# Tusuka Processing Ltd. (Unit-02)

# Executive Summary

# Observations

# Inconsistency in the design report

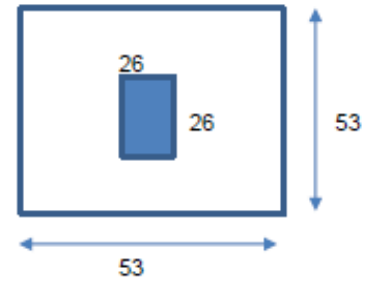
Detailed foundation adequacy check not provided in the design report. Only bearing and punching check of MAT foundation provided. Building engineer is required to check the settlement of the MAT foundation. Also, there is two types of foundation in the building one is MAT with Pile in other part only MAT. So differential settlement also required to address in the design report.

All the serviceability issue as per BNBC not addressed in the design report. Building engineer is required to address all the serviceability issue as BNBC.

**GROUND FLOOR PLAN**

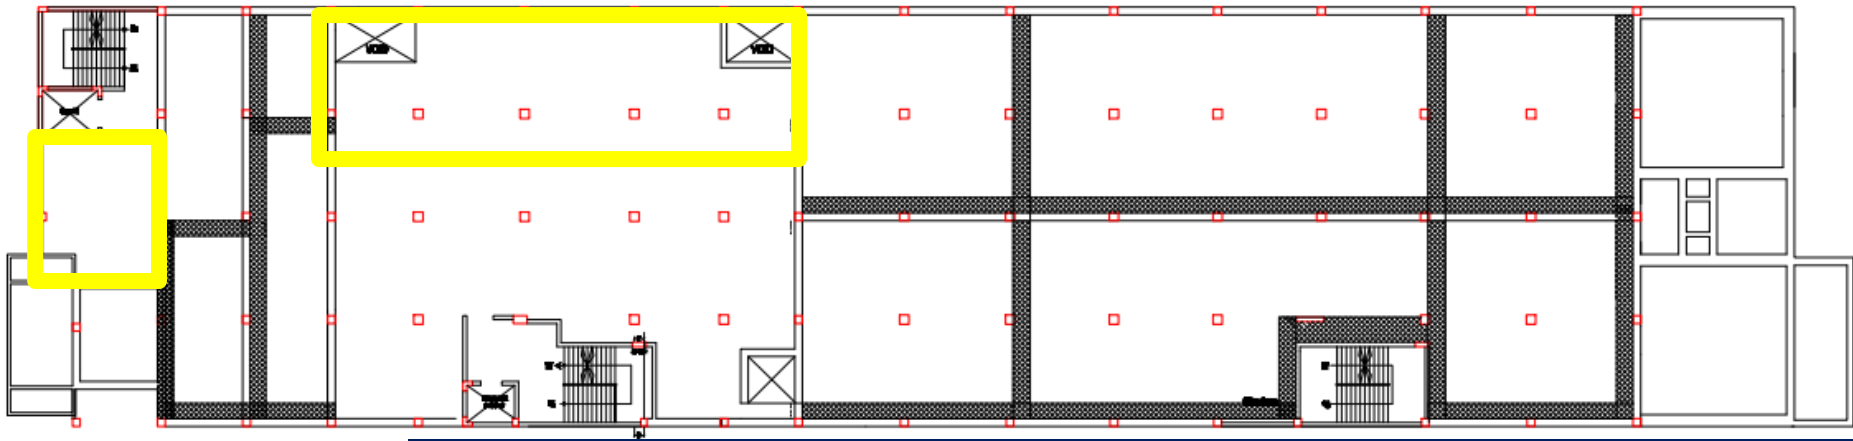
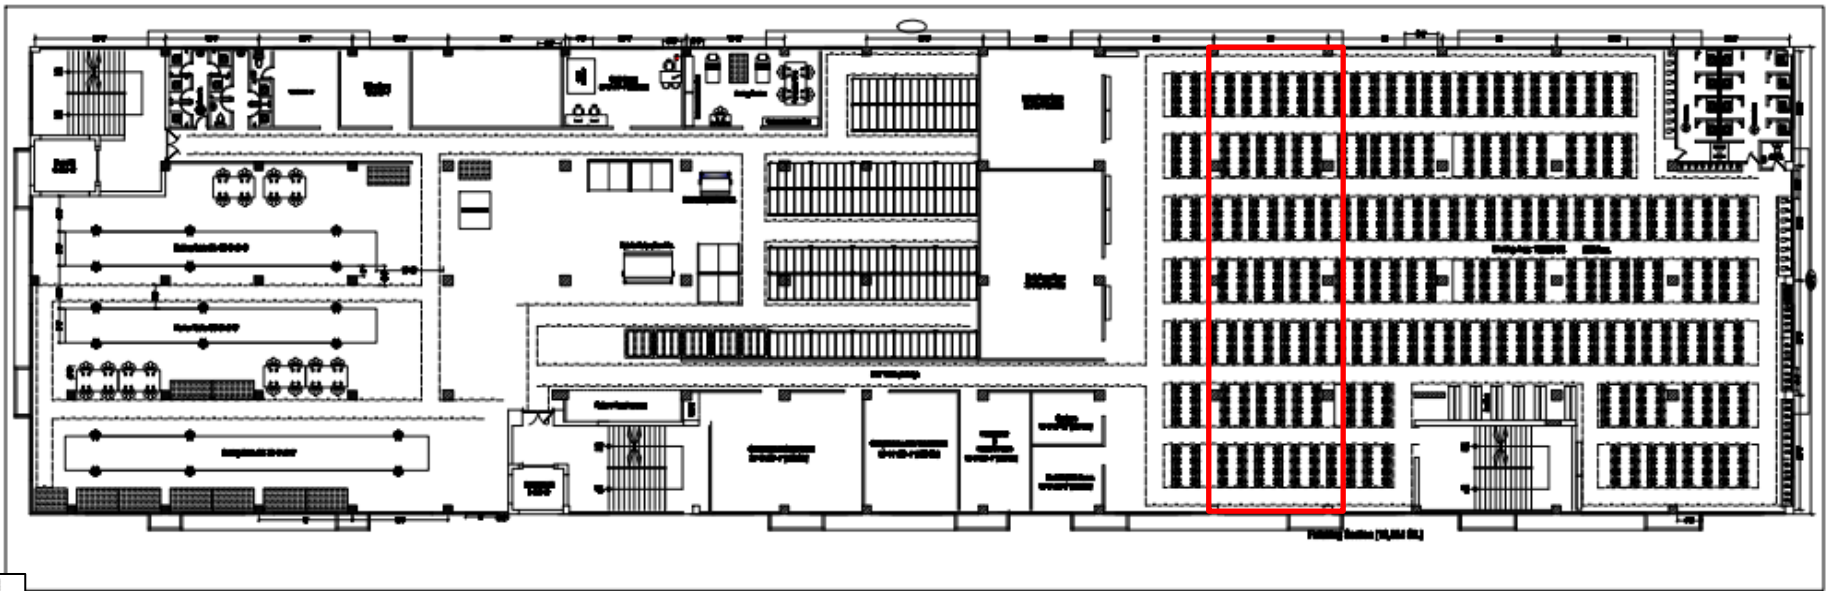
Significant vibration was felt on the ground floor due to operation of machineries. Building engineer is required to investigate the long-term effect of the vibration and suggest proper remediation.

**4TH FLOOR PLAN**

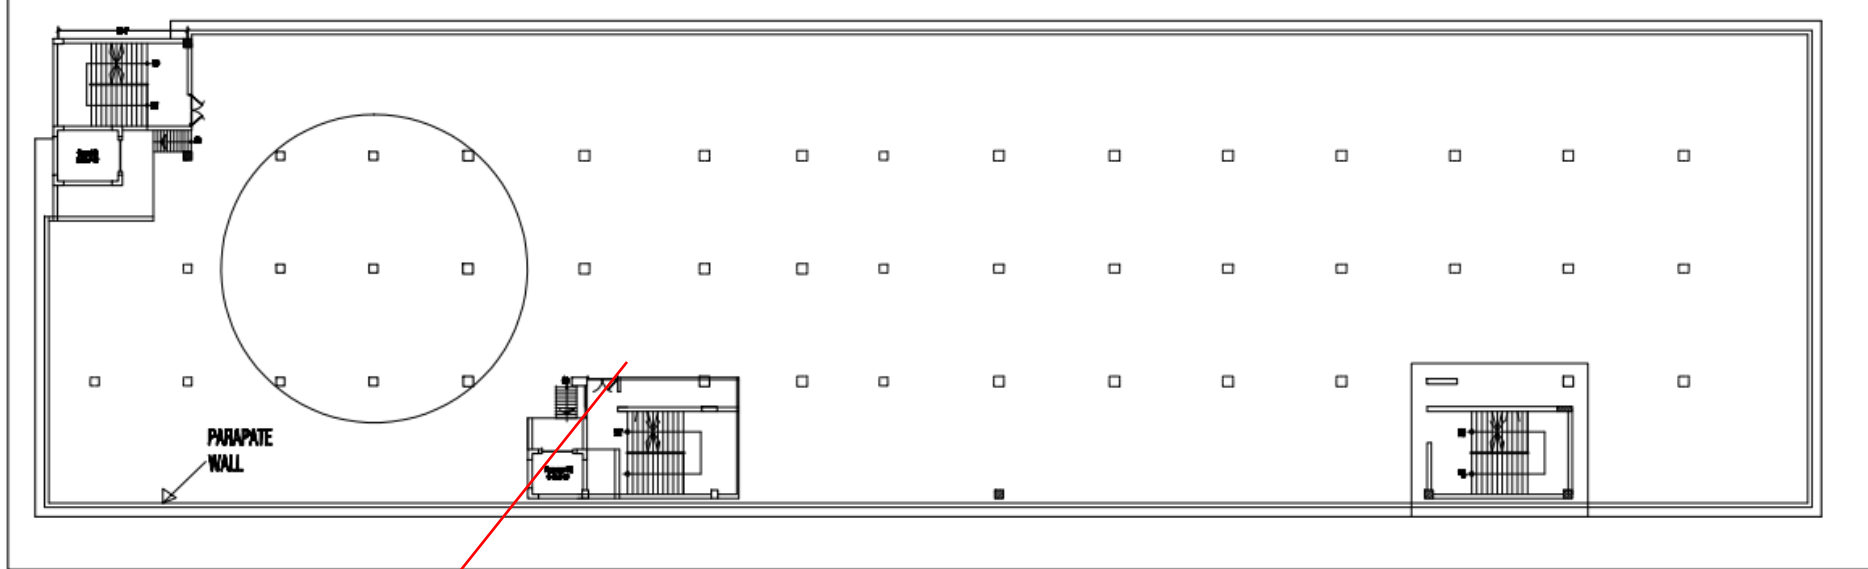
There are some changes in the floor layout plan. The marked bay is not using for the dining purpose.

**ROOF FLOOR PLAN**

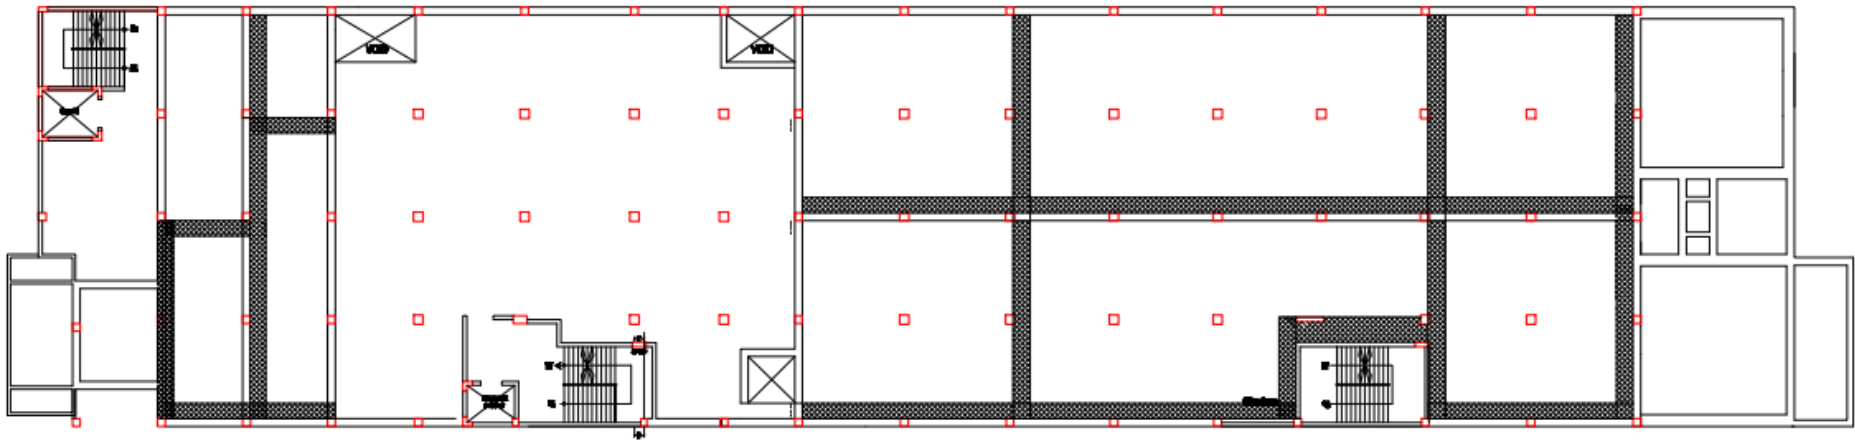
Undocumented steel stair

Roof and helipad load plan not produced. Gardening also not include in the roof layout plan.

**GROUND FLOOR PLAN**

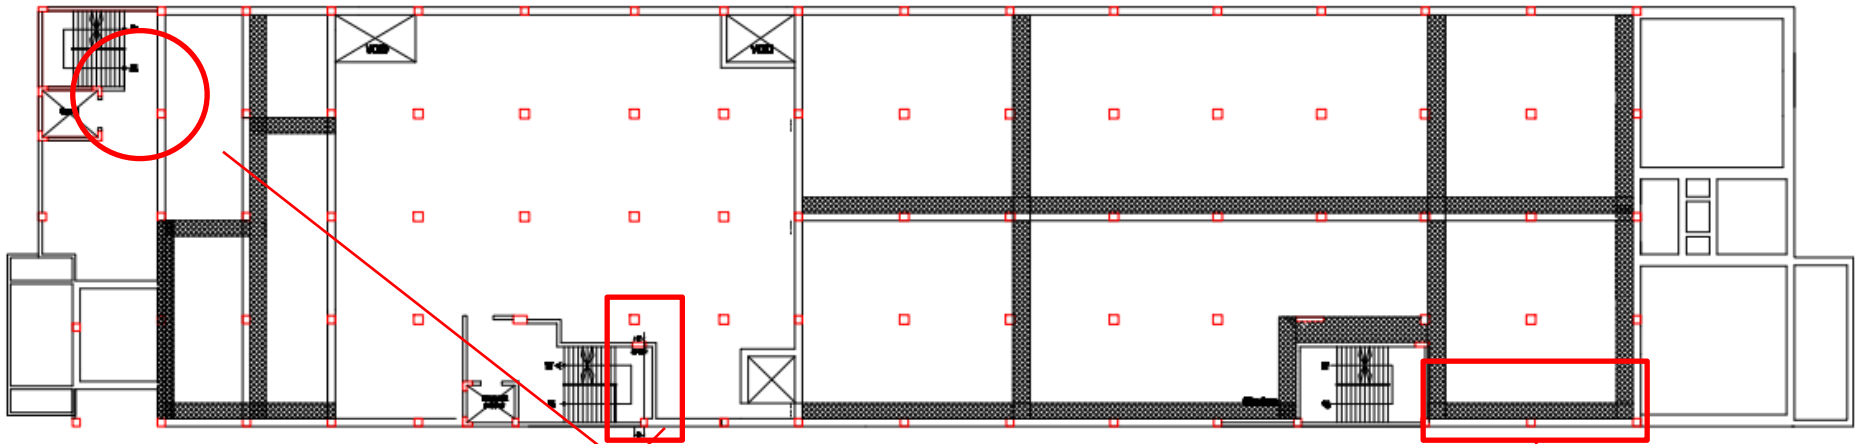
Undocumented loading unloading porch

# Stagnant of water on roof

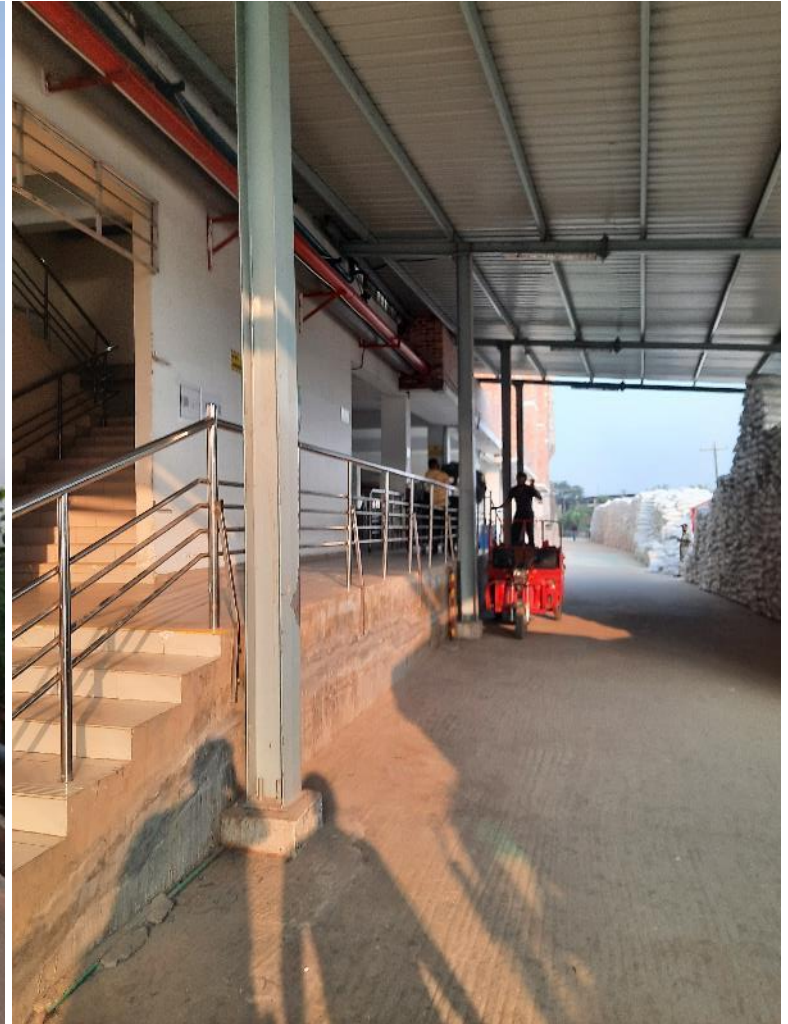
Stagnant of water observed on roof. Building engineer is required to improve the roof drainage system.

# Apparently lack of load transfer media

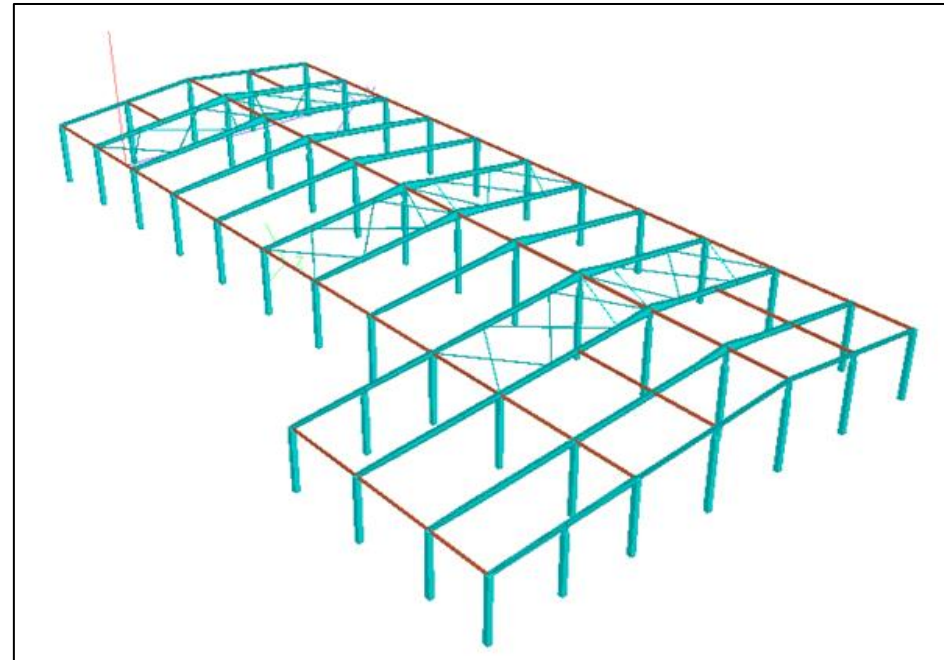
Compression strut/tie beams are not provided in the ridge position along long direction. Building engineer is required to check the lateral stability of the shed.

**WASH UNIT-C  
TUSOKA PROCESSING LTD. WASH UNIT-C, OZONE MACHINE, CHEMICAL SUB-STONE, MEZZANINE FLOOR & OFFICE**

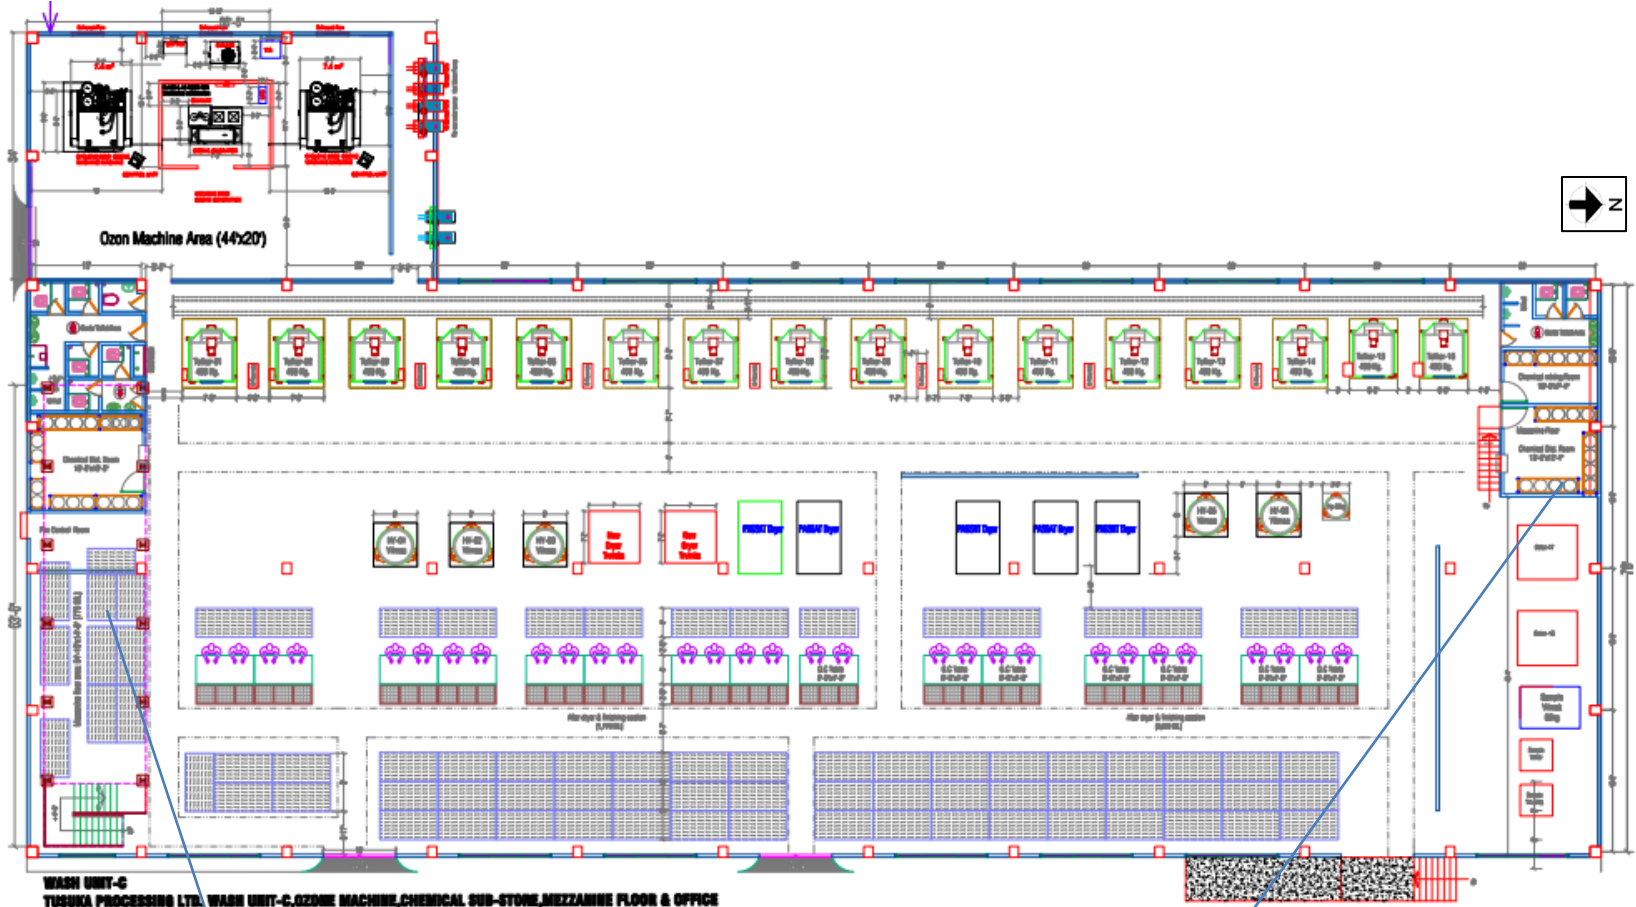
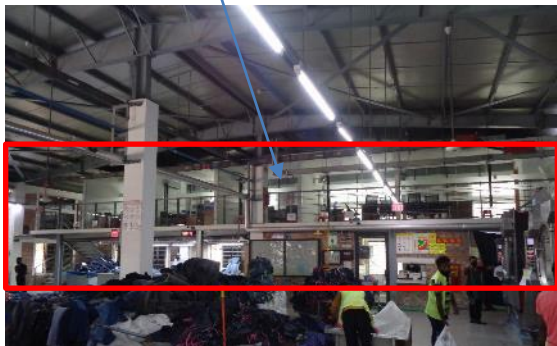
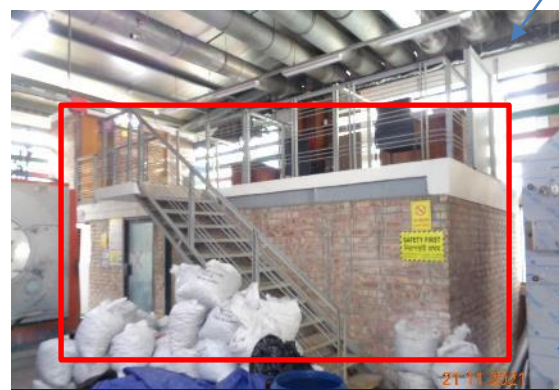
Structurally connected Mezzanine floor at north and south not shown in the as-built architectural and structural drawing.
